# Response to TfL Comments

Title: **Hayes Park West – Response to TfL Comments**

## **APPENDIX A1 SEW – DESIGN AND ACCESS ADDENDUM**

**Addendum:  
response to  
Hillingdon and  
GLA comments**

### GLA Comments item 43, Addendum: Cycle Provision reviewed

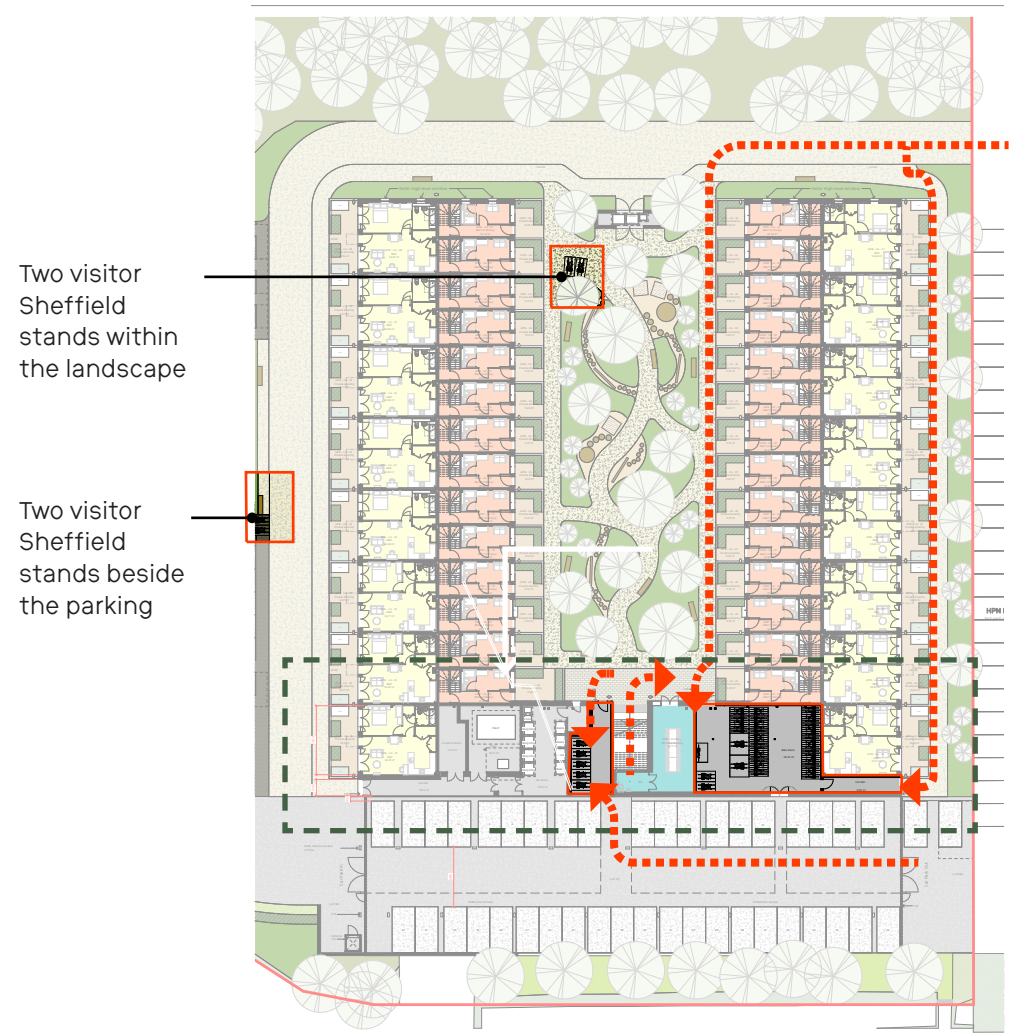
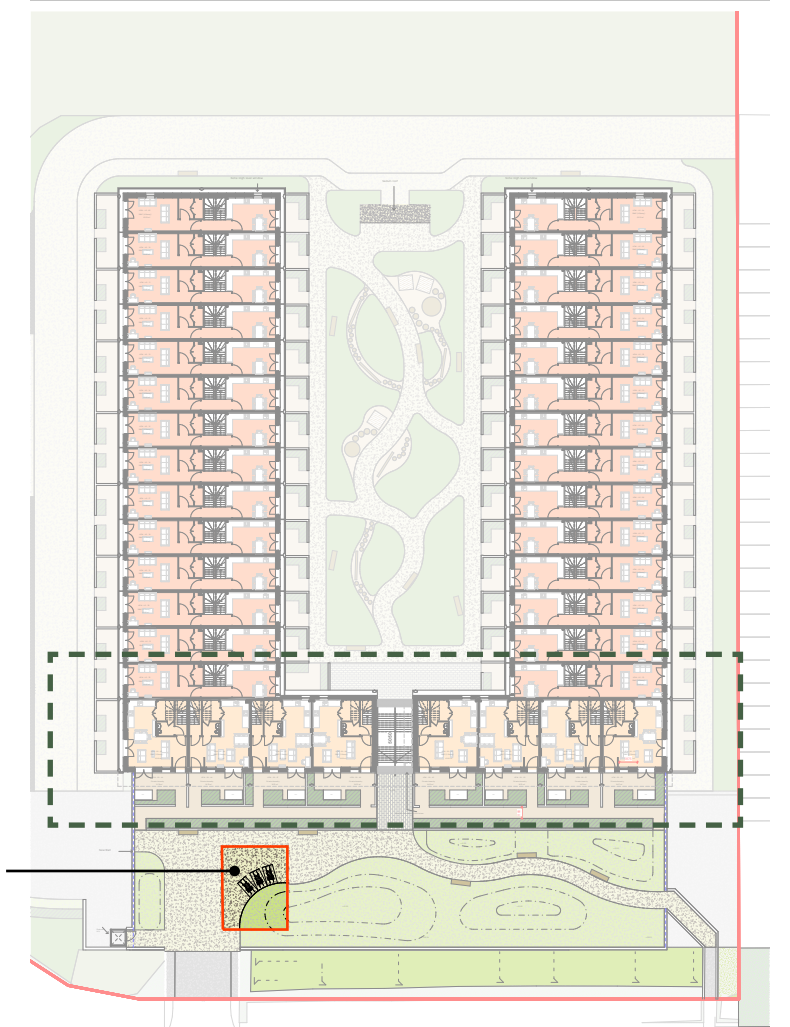
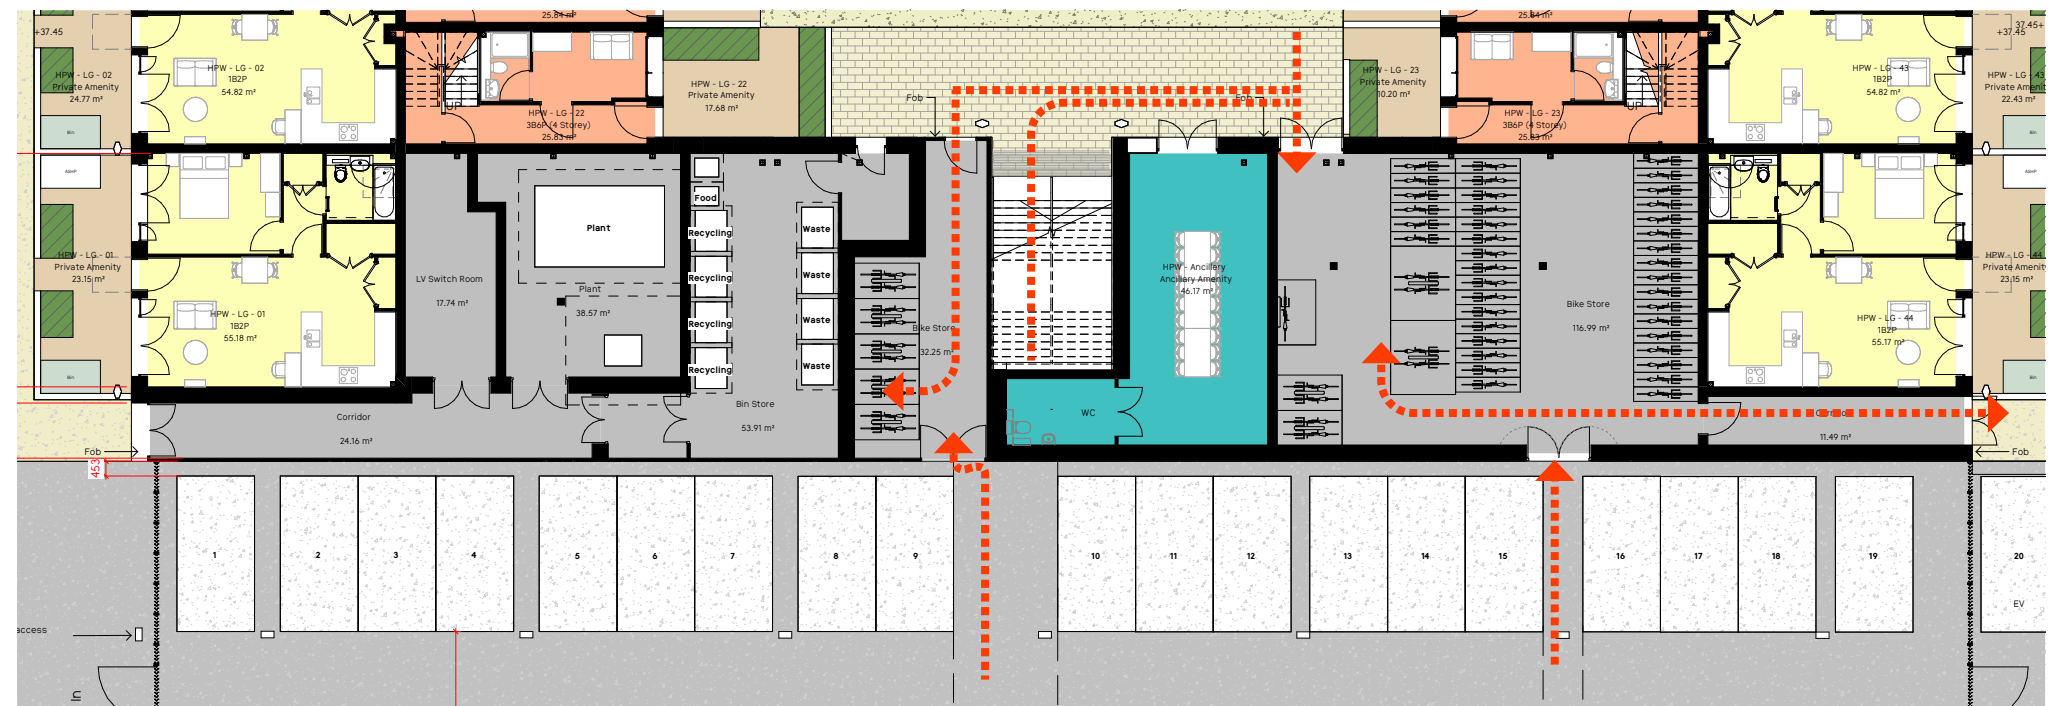
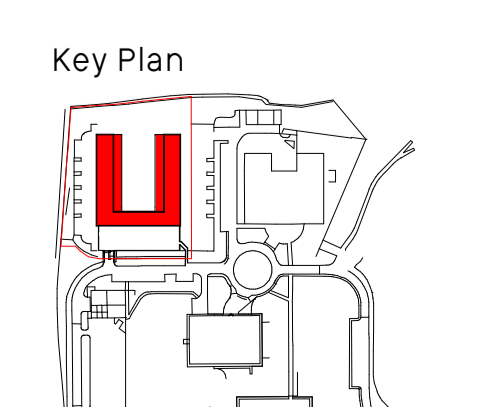
- External door widths are currently shown as 1m; these should be a minimum of 2m, particularly as enlarged cycle spaces are located within these areas.
- Ideally, cycle stores should have a clear width of 3,500mm to accommodate double-stacking racks effectively.
- Where Sheffield stands are provided, the minimum centre-to-centre spacing must be 800mm to ensure usability.
- Short-stay spaces should be clearly identified on drawings and located within 15m of main entrances to ensure genuine usability of the spaces.

An updated plan has been produced by SEW (page 159 of the attached addendum), the architects, showing changes to the cycle

stores in order to be LCDS compliant. This demonstrates doors are 2m wide, that there is a clear width within the cycle store of 2.5m, which is the minimum allowed, 800mm between Sheffield Stands and highlights the location of short stay spaces as requested.

The central cycle store is proposed within the lowered ground floor adjacent to the carpark.

The cycle store to HPW is accessed via the central courtyard externally or via the car park. In addition there is an external exit /access door to the eastern facade. The centralised store will be bright and welcoming.

A bike ramp will also be provided on one side of the central stair leading down from the podium level.
